UNITED STATES PATENT AND TRADEMARK OFFICE

APPLICATION NO.	FILING DATE	FIRST NAMED INVENTOR	ATTORNEY DOCKET NO.	CONFIRMATION NO.
10/087,302	02/28/2002	Morten Eriksen	43708.14	3786
22859	7590	06/15/2004	EXAMINER	
INTELLECTUAL PROPERTY GROUP FREDRIKSON & BYRON, P.A. 4000 PILLSBURY CENTER 200 SOUTH SIXTH STREET MINNEAPOLIS, MN 55402			NATNITHITHADHA, NAVIN	
			ART UNIT	PAPER NUMBER
			3736	7

Office Action Summary

DETAILED ACTION

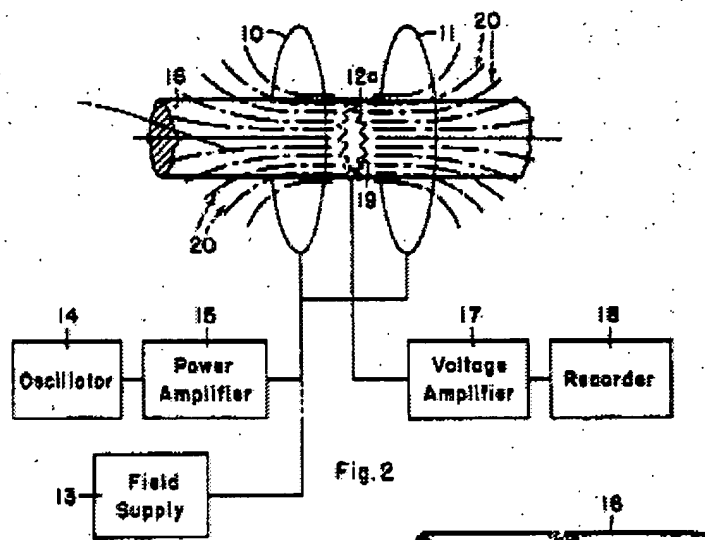
Claim 1: Goldberg et al disclose a device for measuring the movement ("displacements" or "changes in cross-sectional areas") of an object (see col. 1, lines 6-10 and lines 45-50 and see fig. 2 below) comprising: means 13 for creating time-varying magnetic fields at least large enough to surround the object (see col. 6, lines 55-62); electrical circuits 10 and 11 adapted to conform ("embracing" or "contacting engagement") to the surface of the object (see col. 6, lines 47-52); and voltage monitoring means 18 connected to the electrical circuits, whereby motion of the surface creates a measurable change in induced voltage in the circuits that correlates to the movement of the object (see col. 6, lines 27-45).

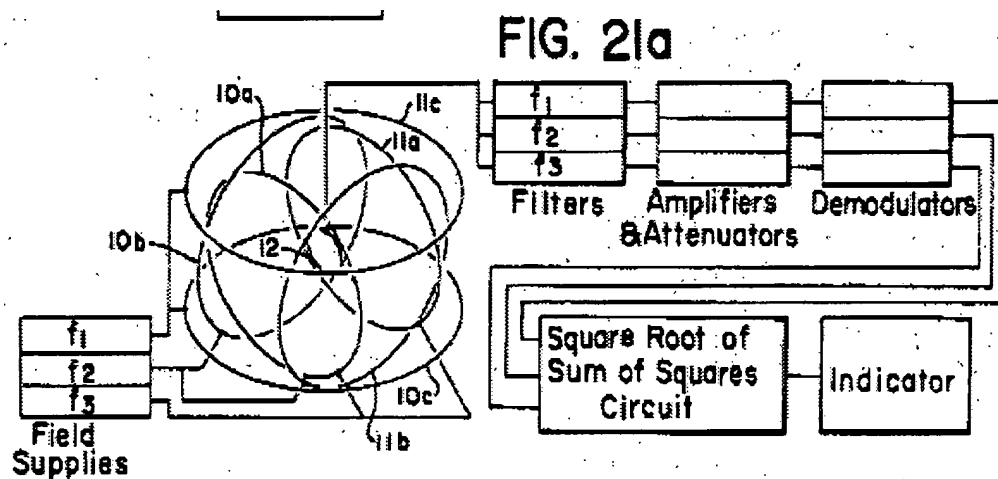
Claim 2: Goldberg et al disclose a computing means (square root of sum of squares circuit, see fig. 21a) suitable for performing a series of algorithmic steps to calculate the volume change of the object from the measured induced voltage (see col. 16, lines 22-39).

Claims 13-15: Goldberg et al disclose the fixed coil means 10 comprises a plurality of small coil elements 10a, 10b, 10c (see fig. 21a).

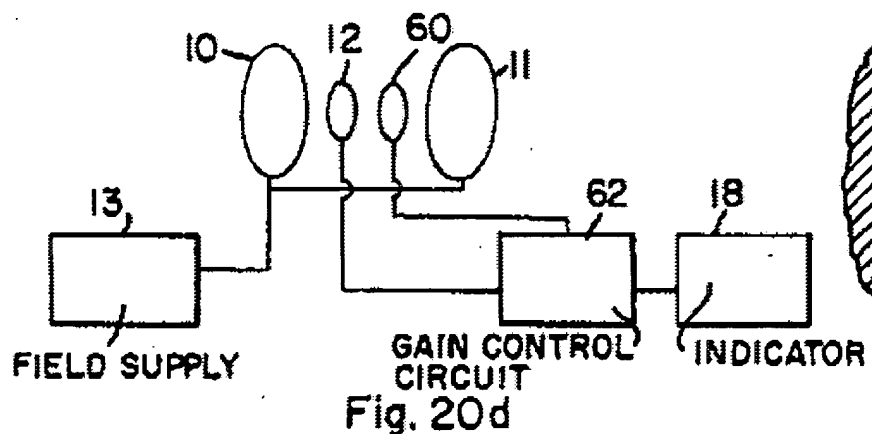
Claim 6: Goldberg et al disclose sensing and control means (control circuit 62) for controlling operation of the device, the sensing and control means being electrically connected to the conductive coil means 10, the fixed coil means 11, and the current generating means 13 (see fig. 20d below).

Claims 7 and 8: Goldberg et al disclose sensing and control means (gain control circuit 62) (see fig. 20d).

Fig 20e

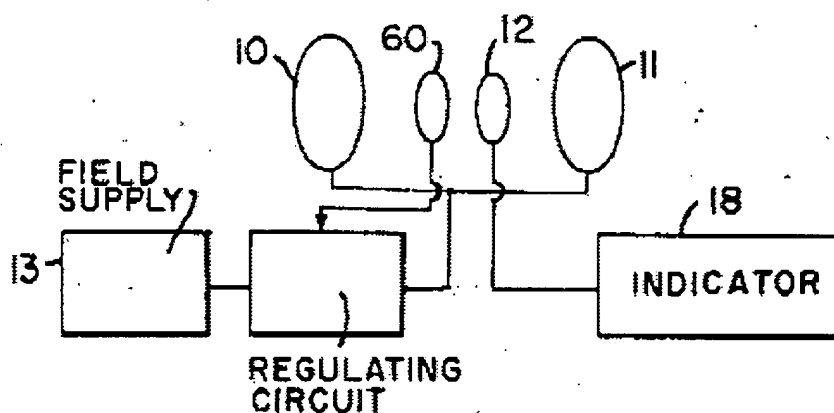
Claims 24 and 25: Goldberg et al disclose sensing and control means (gain control circuit 62 or regulating circuit) of controlling operation of the device (see fig. 20d and 20e).
